Access Compliance Report

Public Rights-of-Way

Intersection ID: 49004	Main Street: LITTLE_GEM_LN	Cross Street: STEELECROFT_PY	Location: E
ADA ID: 6F388DCD95F4	Ramp Type: PerpDiag	Initial Pass/Fail: Fail	Overall Compliance: No
Severity Score: 1.25			
Codes/Mitigation Info/Possible Solution		Field Measurements/Component Compliance

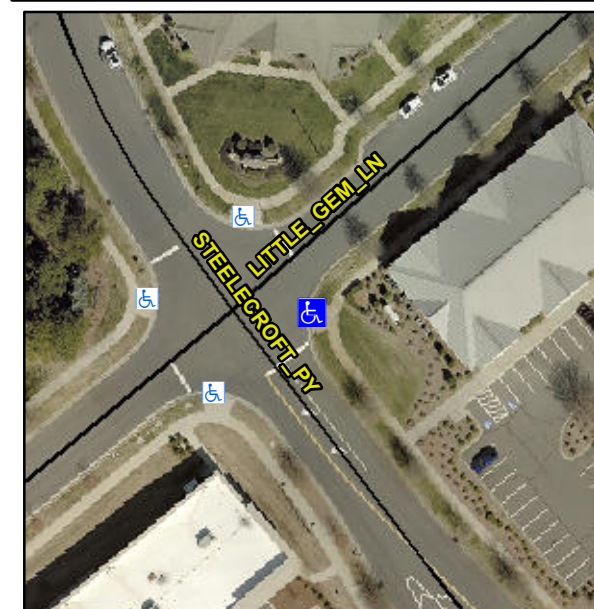
Not Found, R304.5.3

Compliance	Description	Data	Compliance	Description	Data
N/A	Ramp Length (in)	84.5	Yes	Ramp Slope (%)	6.6
Yes	Ramp Width (in)	56.0	No	Ramp XSlope (%)	2.1
N/A	Flare Type LT	N/A	N/A	Flare Type RT	N/A
N/A	Flare Slope LT (%)	N/A	N/A	Flare Slope RT (%)	N/A
N/A	Flare Traversable LT?	N/A	N/A	Flare Traversable RT?	N/A
N/A	Landing Length (in)	N/A	N/A	DWS Provided?	N/A
N/A	Landing Width (in)	N/A	N/A	DWS Contrast?	N/A
N/A	Landing Slope (%)	N/A	N/A	DWS Length (in)	N/A
N/A	Landing X Slope (%)	N/A	N/A	DWS Full Width?	N/A
N/A	Landing Curb? (Y/N)	N/A	N/A	DWS Offset (in)	N/A
N/A	Shared Landing?	N/A			
N/A	Gutter Ponding?	N/A	N/A	Gutter Slope (%)	N/A
N/A	Gutter Lip Ht (in)	N/A	N/A	Gutter X Slope (%)	N/A
N/A	Painted X Walk1?	No	N/A	Painted X Walk2?	No
	X Walk 1 Direction	To NW		X Walk 2 Direction	To SW
N/A	X Walk 1 Width (in)	N/A	N/A	X Walk 2 Width (in)	N/A
	X Walk 1 Slope (%)	2.1		X Walk 2 Slope (%)	0.4
	X Walk 1 X Slope (%)	1.3		X Walk 2 X Slope (%)	0.3

Remove & Replace Curb Ramp With Two New Directional Ramps or Equivalent.
